We wish to thank the reviewer for carefully reading our manuscript and for providing suggestions which helped us to improve the manuscript. In the following, the questions and comments raised by the reviewer are marked in blue and our answers are written in black.

Figure 1. Deviation between PAS and TAS as a function of ambient pressure color-coded with the angle of attack (AOA). Markers represent measurements at 1Hz collected during the SALTRACE campaign.

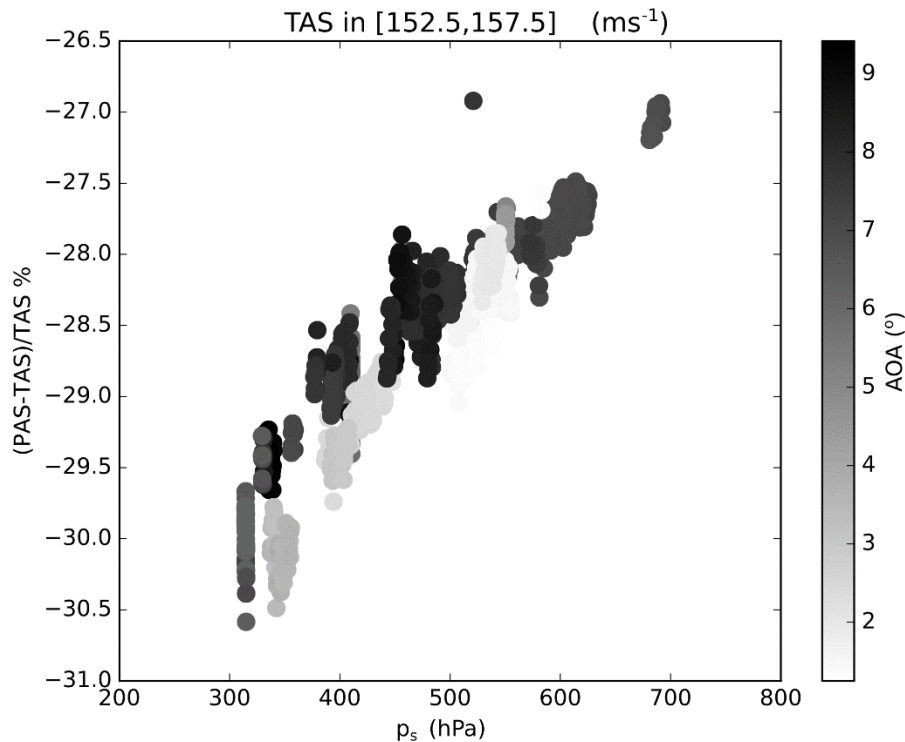
The angle of attack (AOA) of the Falcon is briefly mentioned in section 2.1.2. It appears that the AOA is held constant for all flight conditions used in the simulations such that the orientation of the probe is always aligned with the local flow, or at least in so far as the error associated with the misalignment is negligible. Given that the simulations are done over a very large range of pressure and TAS and that an aircraft's AOA maybe expected to change by degrees over this range, it would be useful to see some justification for this statement.

We have performed numerical sensitivity studies related to the dependency of the results on AOA. Figure 1 (in the reply) shows the deviation between PAS and TAS as a function of ambient pressure color-coded with the angle of attack (AOA) for the arbitrarily chosen TAS range from 152.5 m/s to 157.5 m/s from measurements during the SALTRACE campaign. A TAS range had to be chosen for this figure because the deviation between PAS and TAS depends also on TAS. However, the picture is similar for other TAS ranges and shows that the AOA has only a minor impact on the measurements ( $(PAS-TAS)/TAS$  changes less than 2% when the AOA is changed). Therefore, we chose a median AOA value ( $4^\circ$ ) for our analysis.

Figure 2. Deviations of total pressure measured by CAS and by the Falcon CMET system during SALTRACE (left), and the DC-8 MMS system during ATom-1 (right), respectively.

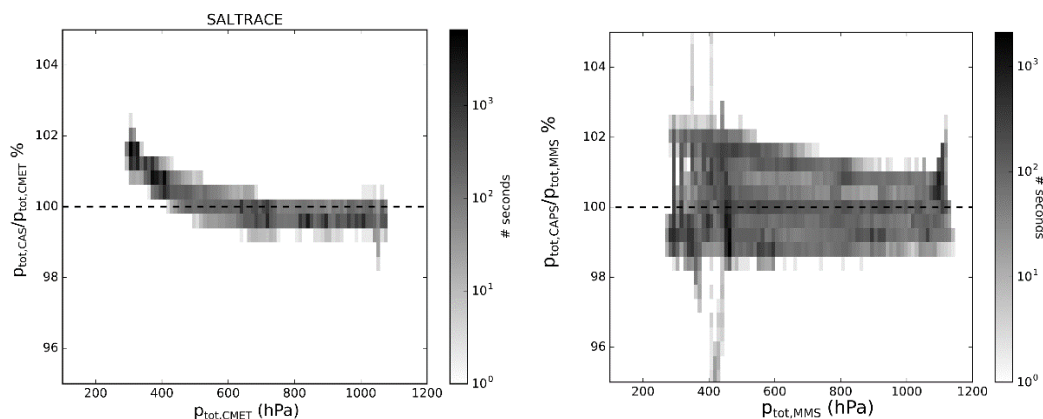
4.5 Are the uncertainties of the DC-8 MMS known? Are they comparable with those of the CMET?

Yes, the two uncertainties are similar and represent errors smaller than 2% on the total pressure. Figure 2 shows the deviation of the total pressure between CAS and the Falcon CMET system during SALTRACE and between CAS and the DC-8 MMS system during ATom-1.

Figure 3. Frequency of AOA vs. true air speed (TAS) during the SALTRACE campaign in 2013.

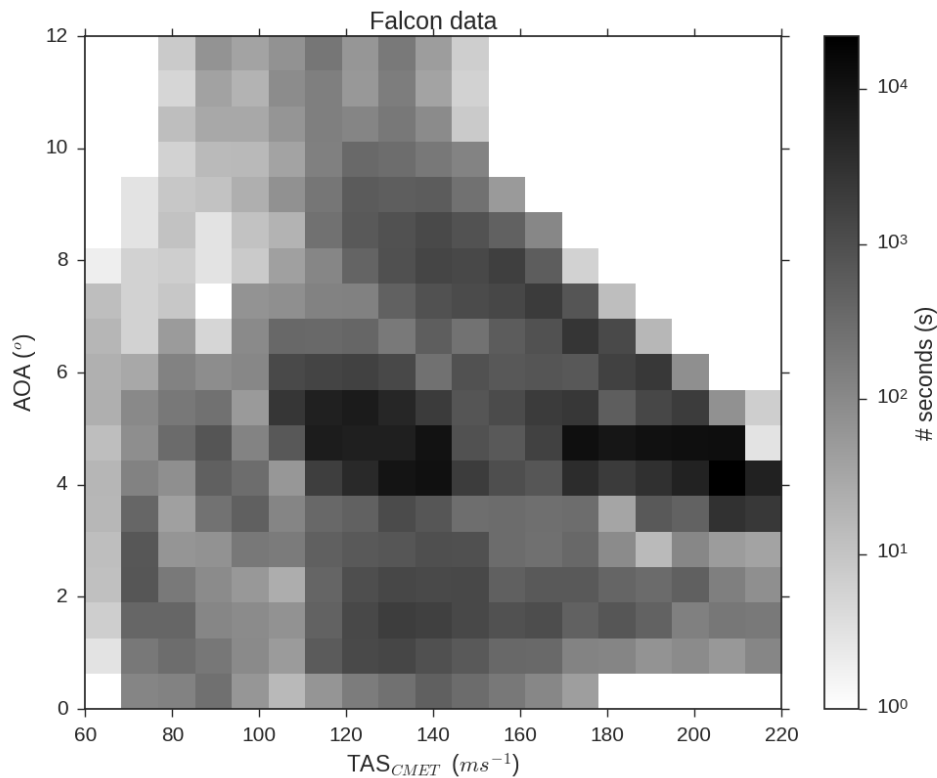
8.23 Mention should be made to confirm if aircraft angle of attack changes with TAS in this model (here and elsewhere).

The simulations presented in the manuscript were made for a fixed AOA (4°). This AOA was selected to represent the median conditions as visible in Figure 3. Also, it can be seen from Figure 1 that changes of the AOA have only a minor impact on the relative deviation of PAS from TAS.
